Bulletin: SB15050025

Subject: New Crankshaft Pulley- Jumpy-Expert-Scudo 1.6

This bulletin is issued to clarify the impact of the crankshaft pulley change on PSA G9 engine on existing and new compressor drive kits.

Original Crankshaft pulley until Jan 2015:

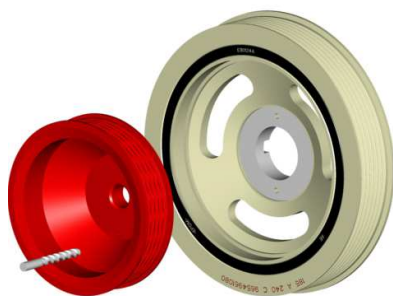
Early this year, PSA replaced the original cast iron crankshaft pulley by a steel one. The original cast iron pulley has the PSA reference: **185 A 240C 9654961080**

The new steel pulley has the PSA reference: **A 12 9810714580**

It is not possible to install an additional drive pulley on the new steel crankshaft pulley.

To install the Mount and Drive Kits **KC12050270E** and **KC 12060276E**, it is necessary to remove the steel pulley reference A129810714580 and install the reference: 185 A 240C 9654961080.

The cast iron part is available in the aftersales organization of PSA.
